CO3275 – Northfield BF 0241(58)

ADDENDUM #2

Changes have been made to the documents located on the Bid Opportunity website as noted below:

TYPICAL WINGWALL PILE SOCKET DETAIL
(NOT TO SCALE)

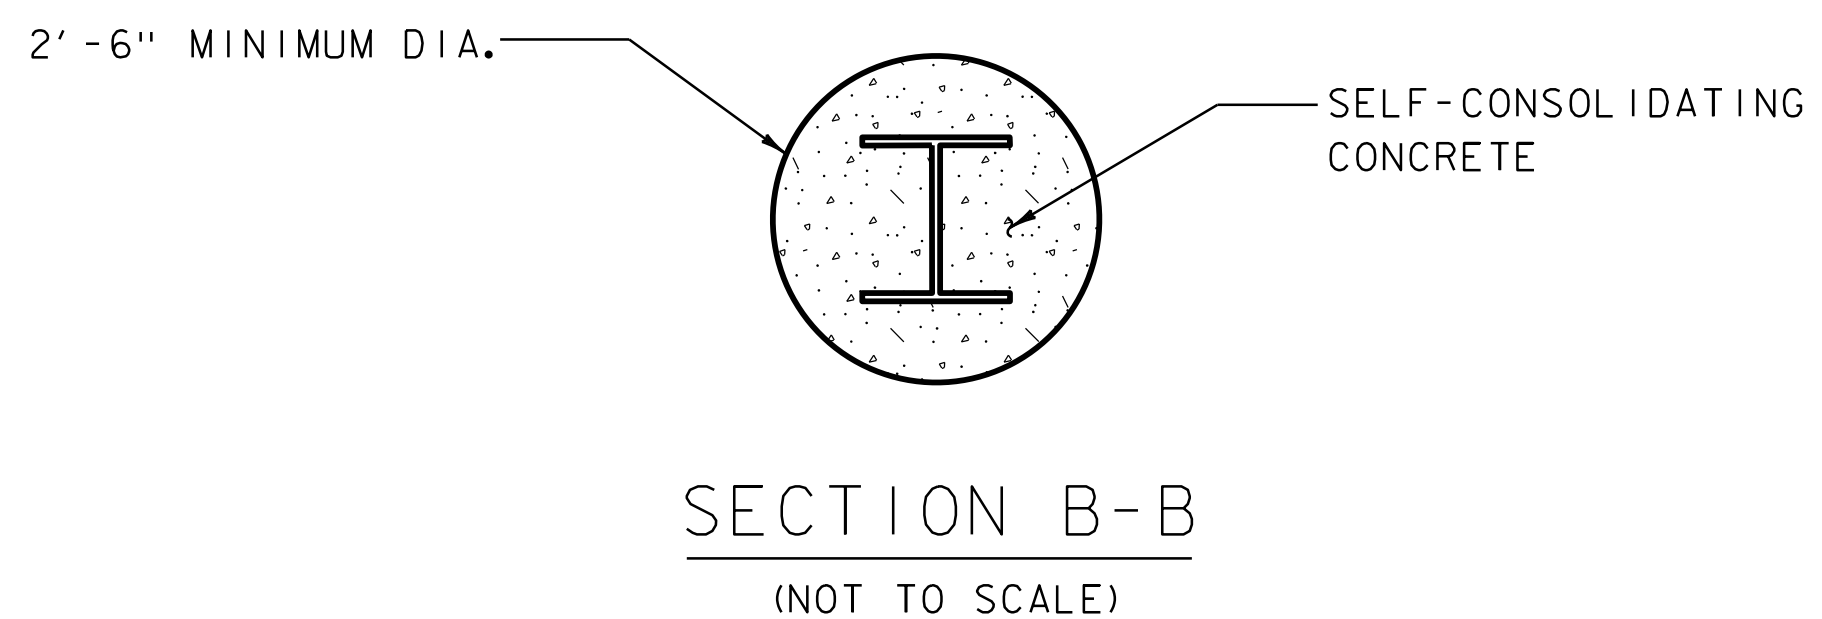
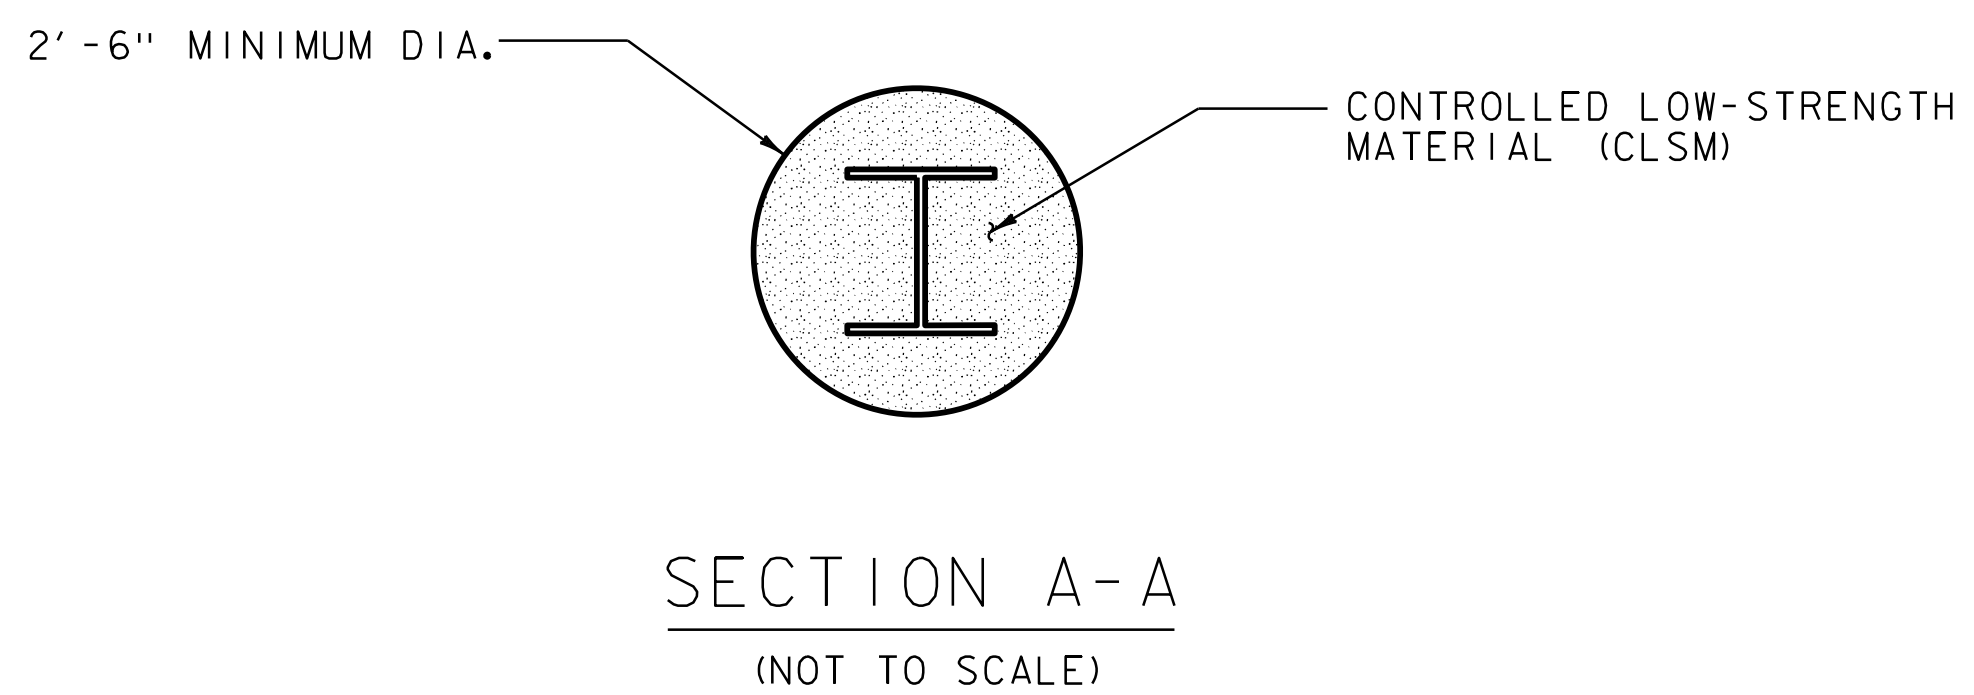
ADDENDUM	REVISION	PLOT DATE	DESCRIPTION	BY
△	1	14-MAY-2026	NOTE ADDED	S. BROWN

1. FOR ABUTMENT PILE INFORMATION REFER TO 'ABUTMENT PILE DETAIL SHEET'.
2. CONCRETE WALL PANELS NOT SHOWN FOR CLARITY.
3. THE CONTRACTOR SHALL NOTIFY THE ENGINEER IF ROCK IS ENCOUNTERED 5'-0" OR GREATER BELOW THE ESTIMATED TOP OF ROCK ELEVATION AND ABOVE THE MAXIMUM PILE TIP ELEVATION IN SOIL SHOWN IN THE WINGWALL PILE SUMMARY TABLE. DRILLING OPERATIONS SHALL CEASE IF ROCK IS NOT ENCOUNTERED UPON REACHING THE MAXIMUM PILE TIP ELEVATION IN SOIL SHOWN IN THE WINGWALL PILE SUMMARY TABLE AND THE PILE MAY BE TERMINATED AT THAT ELEVATION.
4. PILES WILL BE PLACED WITHIN THE PRE-EXCAVATED PILE SOCKETS, BASES CAST INTO CONCRETE, AND BACKFILLED UTILIZING SPECIFIED MATERIALS. SEATING THE PILES INTO THE BEDROCK SOCKETS WITH AN IMPACT PILE DRIVING HAMMER IS NOT REQUIRED.

REINFORCING STEEL SCHEDULE

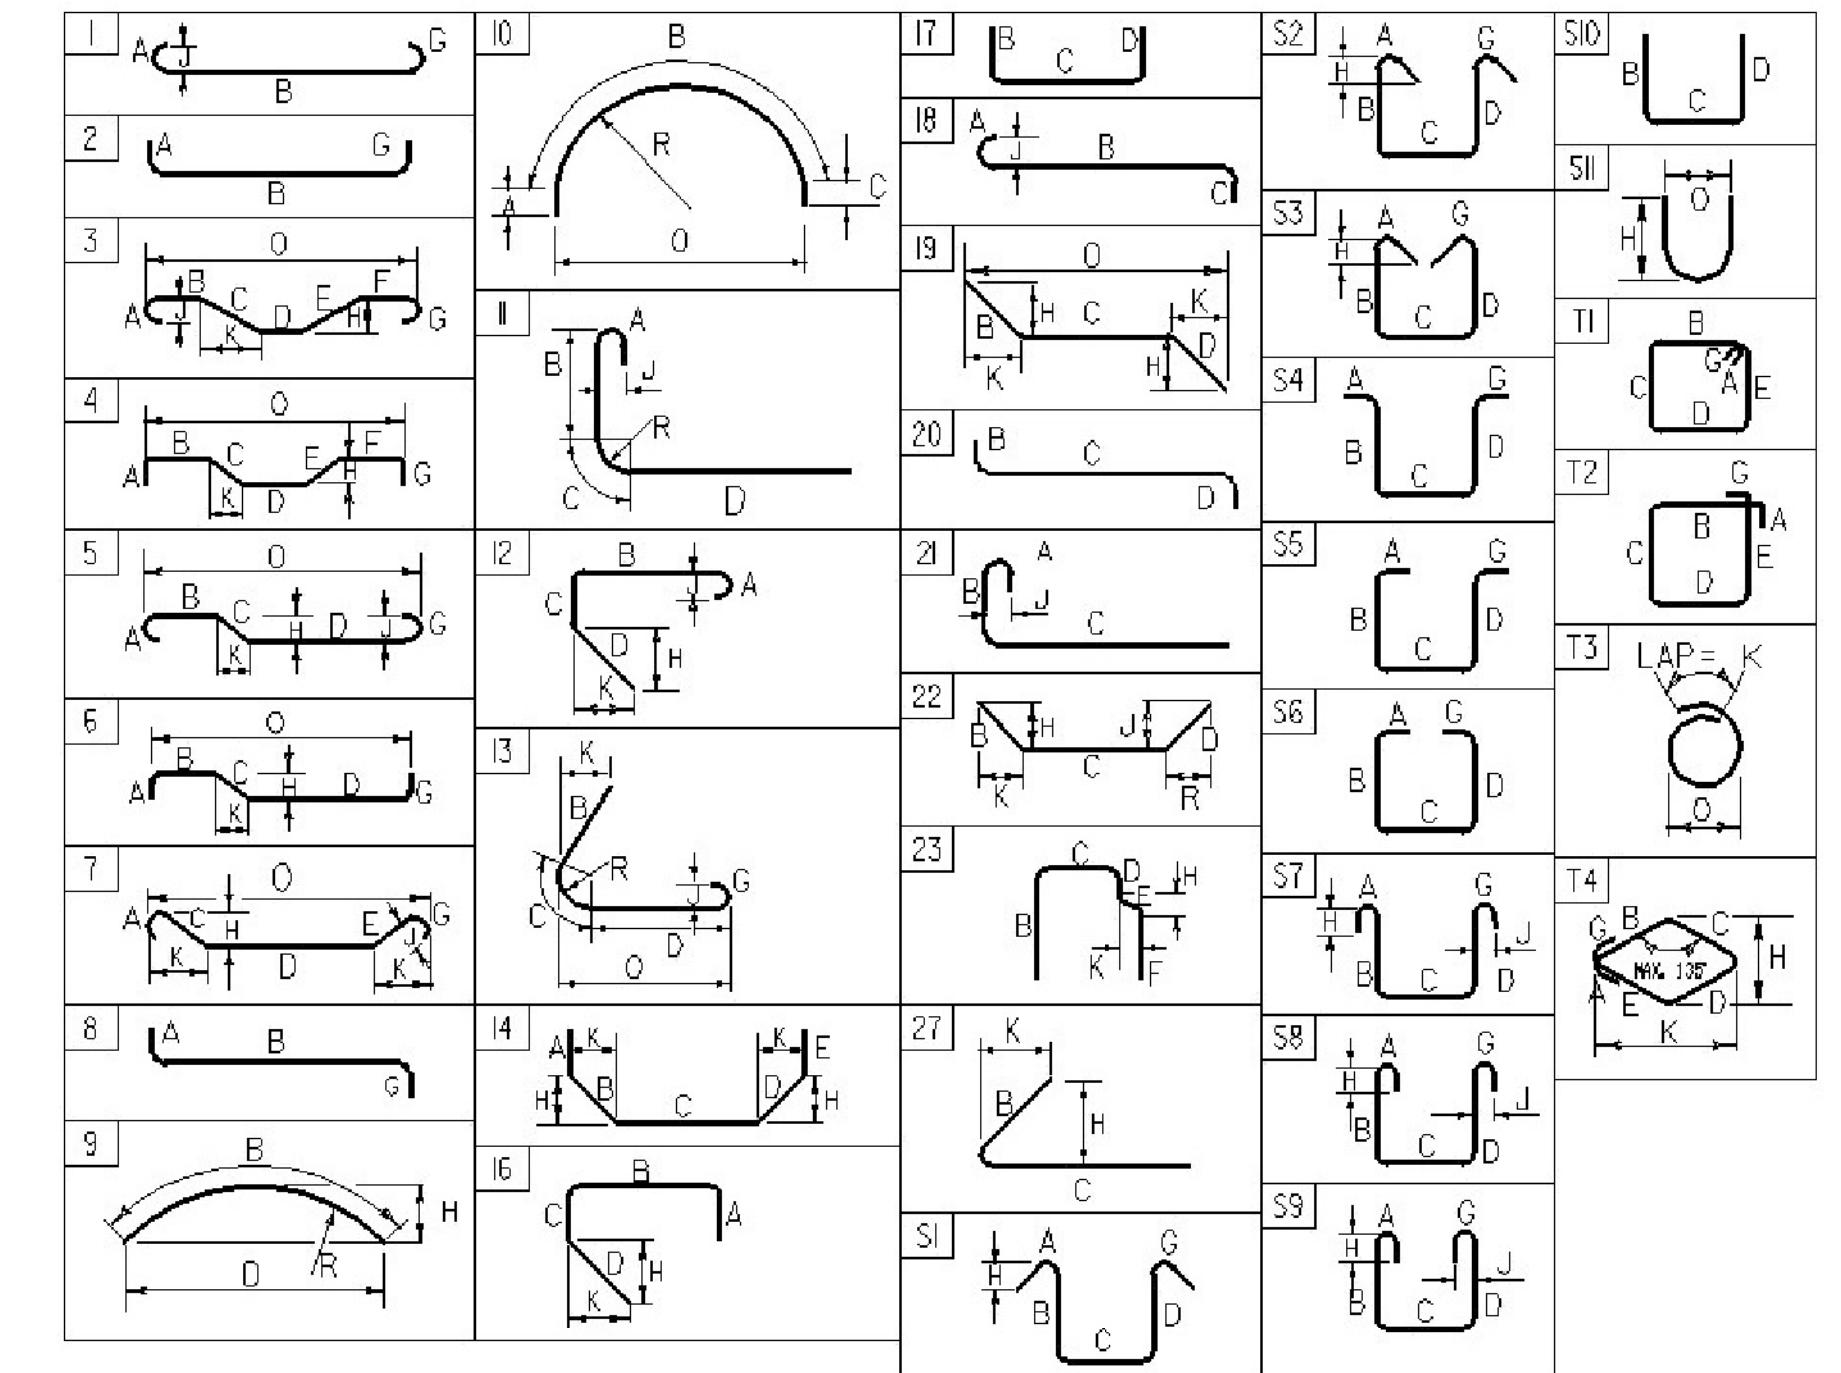
ADDENDUM	REVISION	PLOT DATE	DESCRIPTION	BY
△	I	14-MAY-2026	REINFORCING REVISED	S. BROWN
